Re: **SCI-823-6.81, Portsmouth Bypass Project, PID 19415**  
**Addendum to Report: Shumway Hollow Road (TR 234) Interchange**  
Embankment Stability, Time-Rate of Consolidation, Soil Cut Slope Stability  
DLZ Job No.: 0121-3070.03, Document No. 107

DLZ has reviewed ODOT-Office of Geotechnical Engineering's (OGE's) Stage I review comments (dated January 31, 2007) for Phase 1 of the SCI-823 project. In compliance with the review comments, DLZ has modified the slope stability analyses and time-rate of consolidation calculations for the Shumway Hollow Road (TR 234) interchange embankments. This document also elaborates on our previous recommendations for soil cut slopes and includes the output of the associated stability analyses.

WICK DRAIN AND INSTRUMENTATION PLAN  
 SHUMWAY HOLLOW RD (TR 234) INTERCHANGE

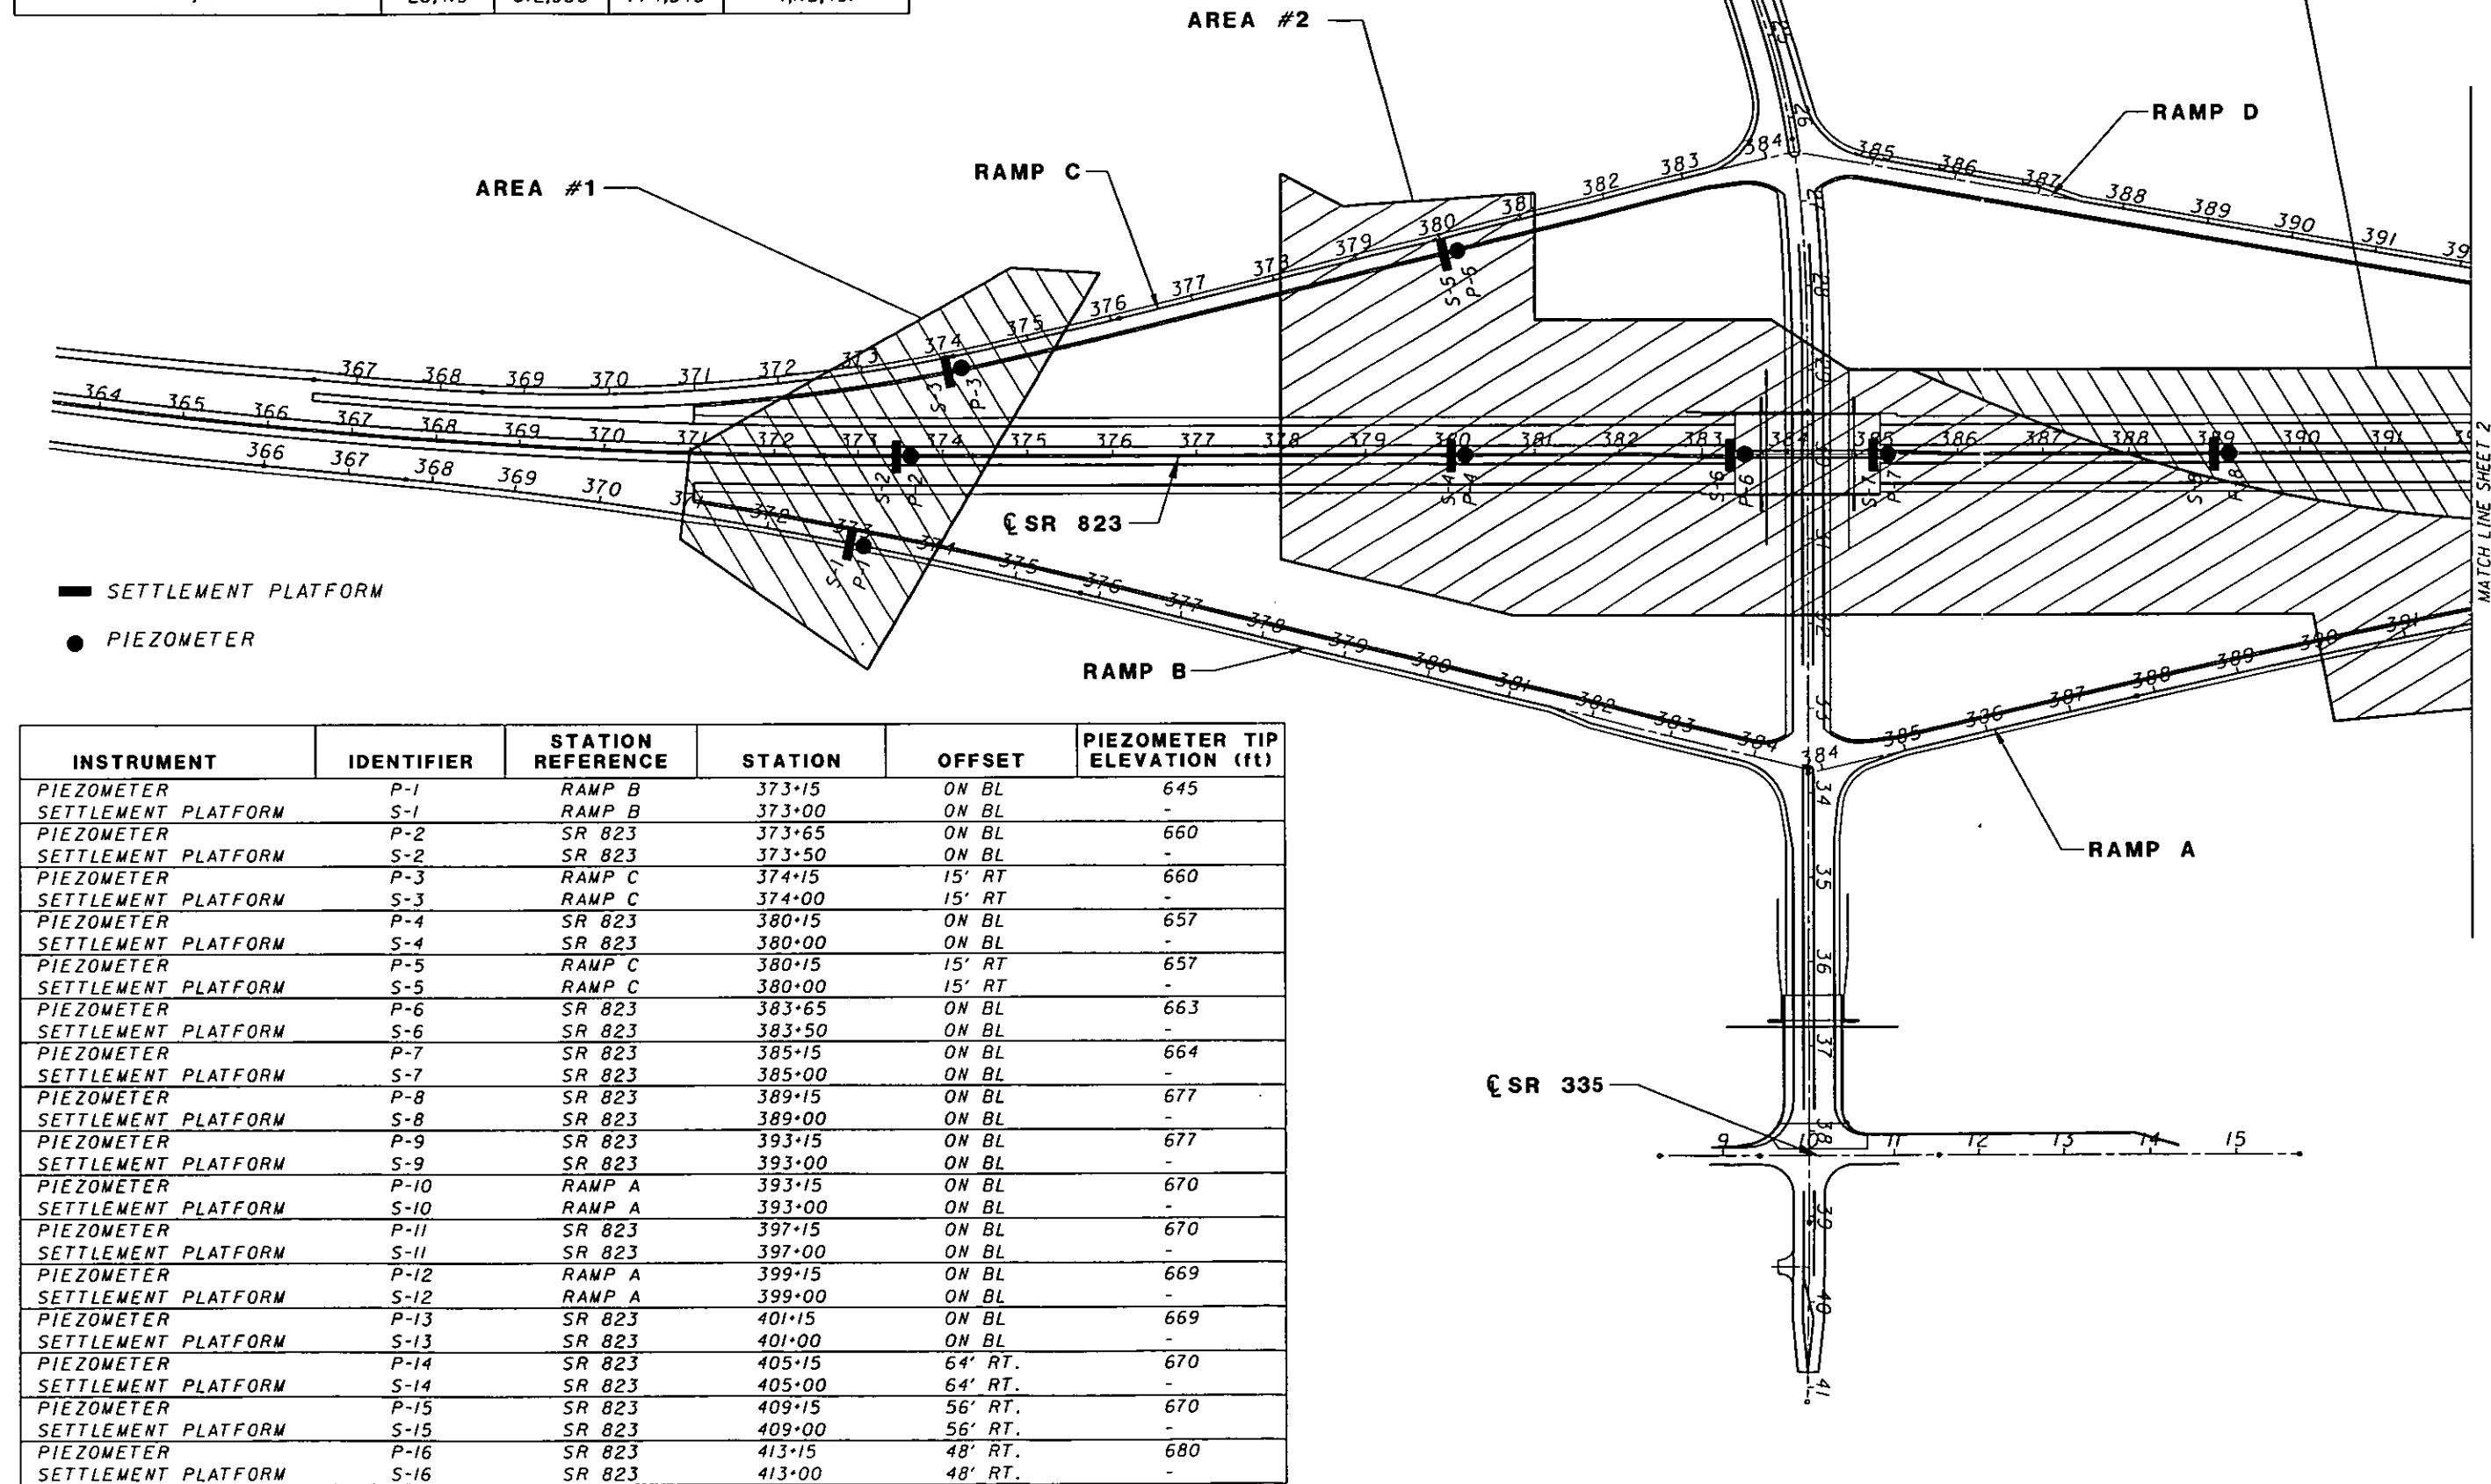
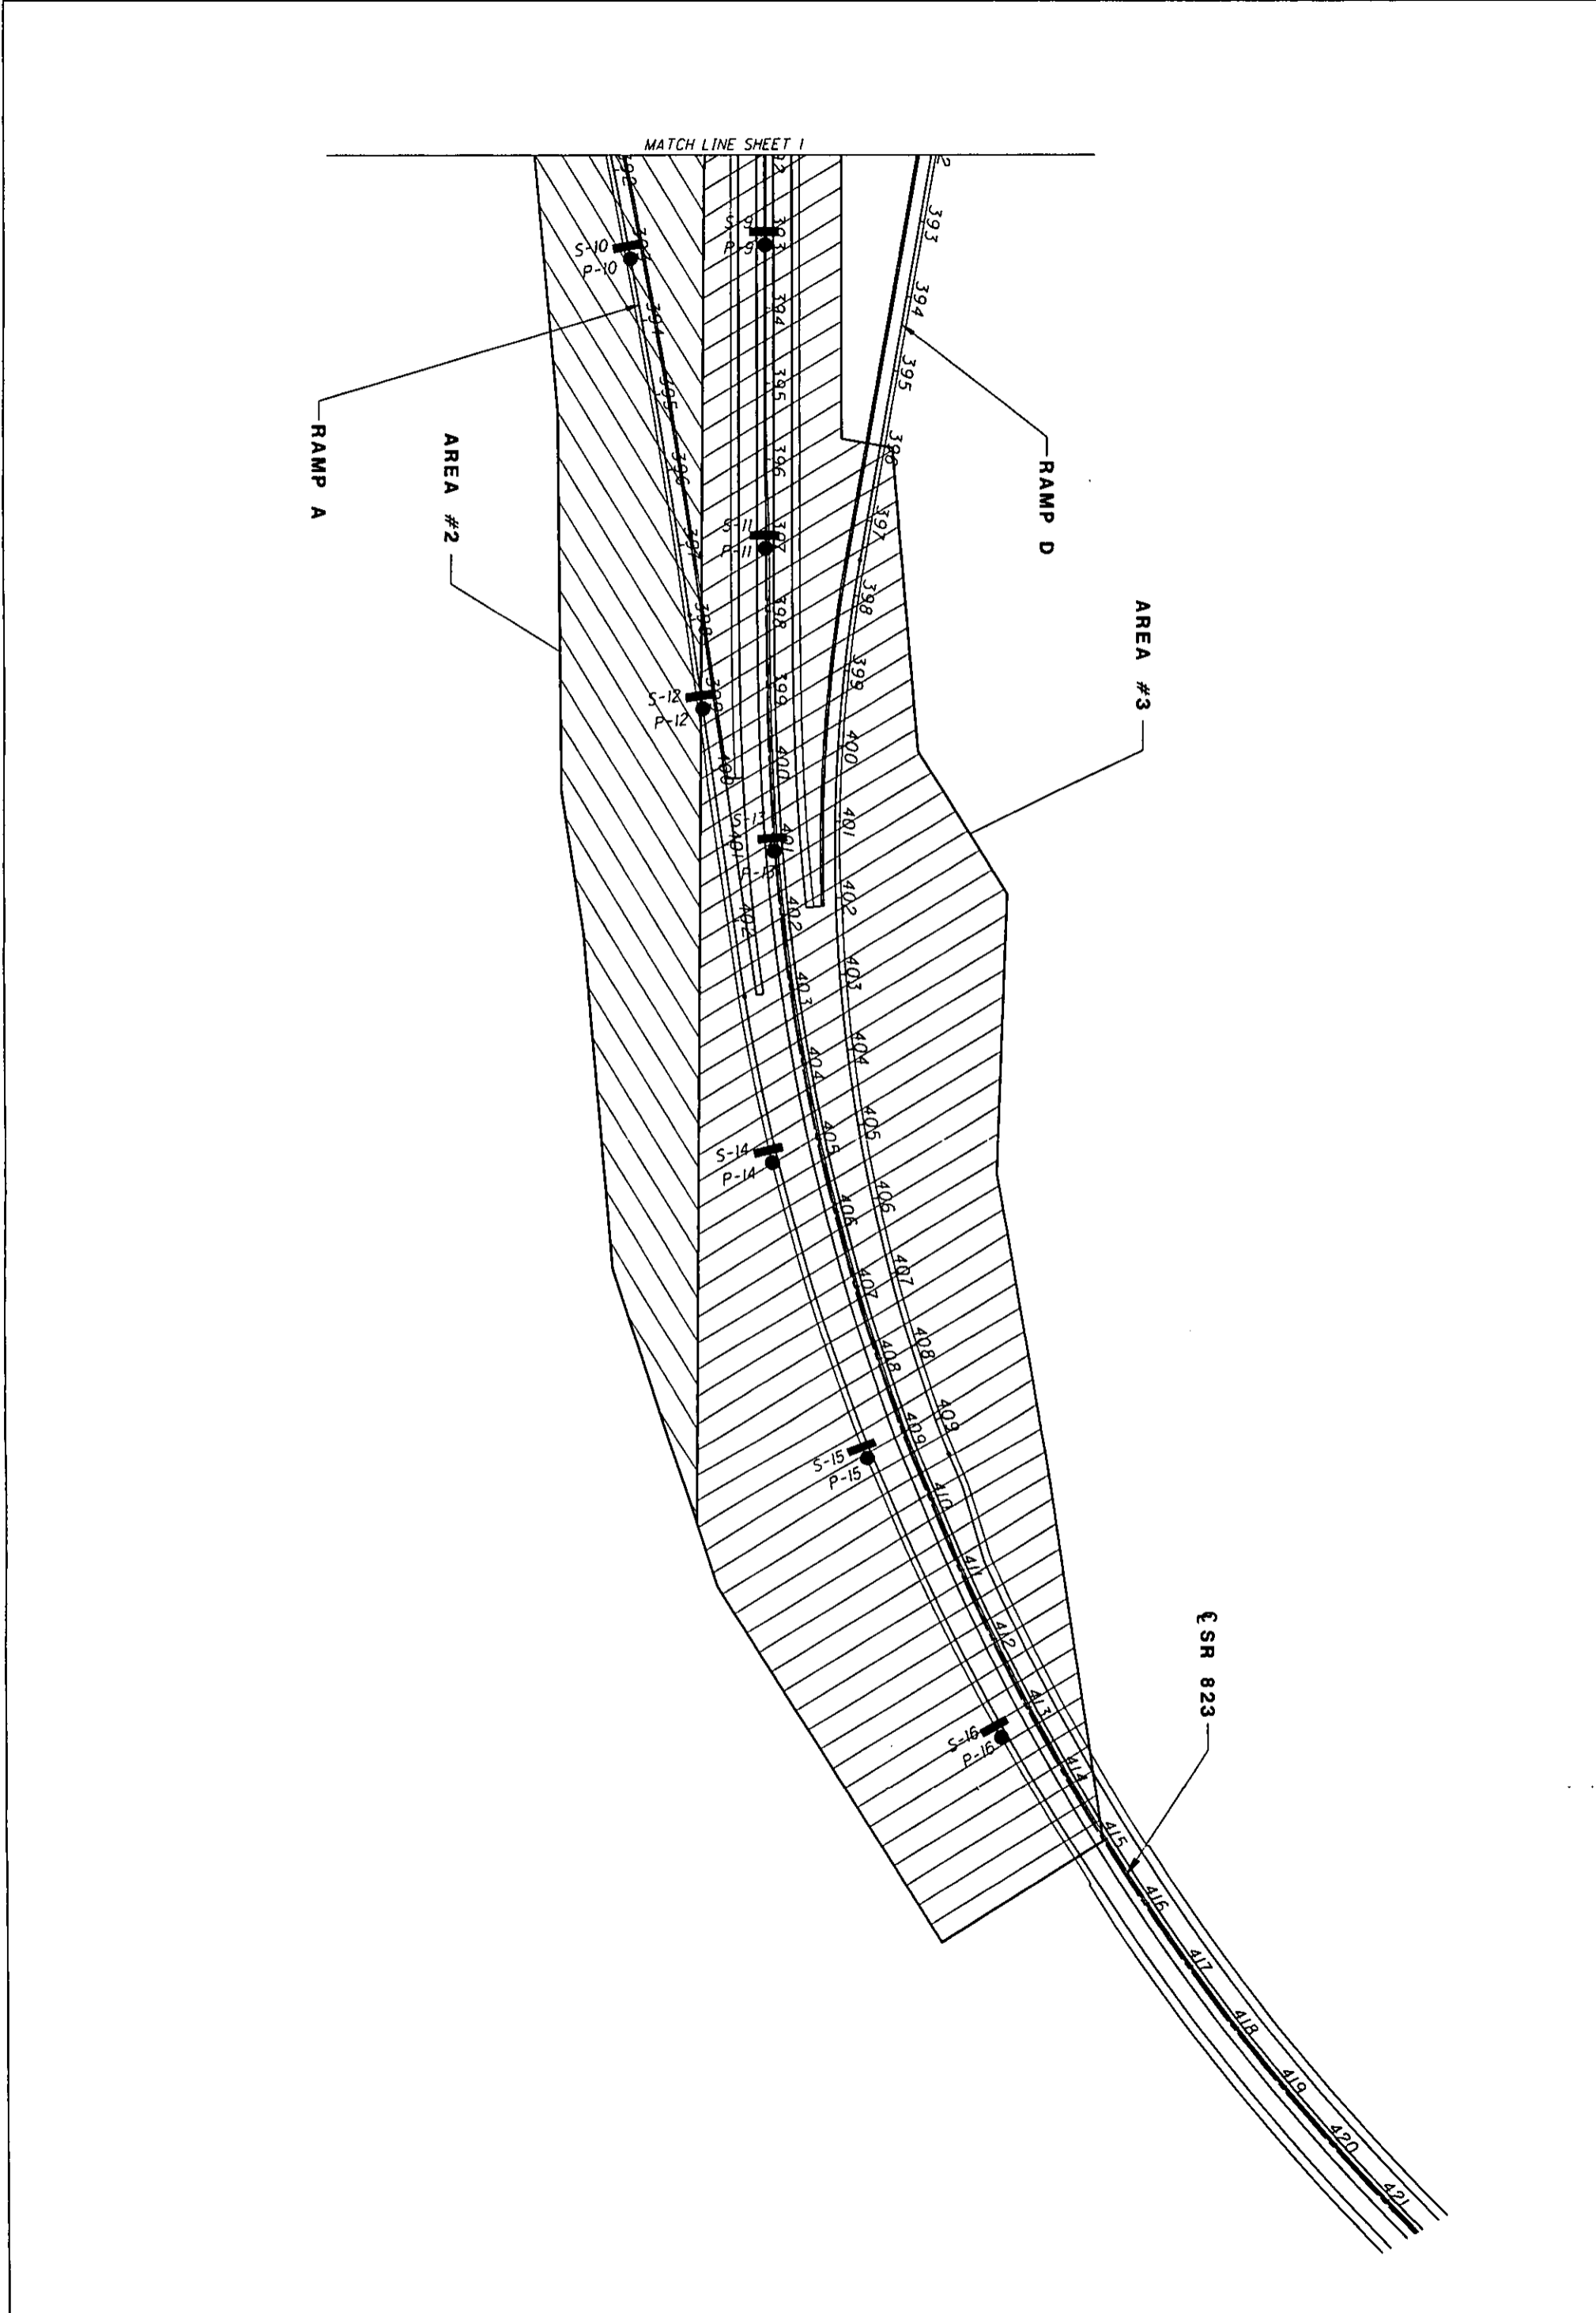
Due to changes in the time-rate of consolidation calculations and the addition of alternate wick drain spacing options, an update of the wick drain and instrumentation plans for the interchange are attached.
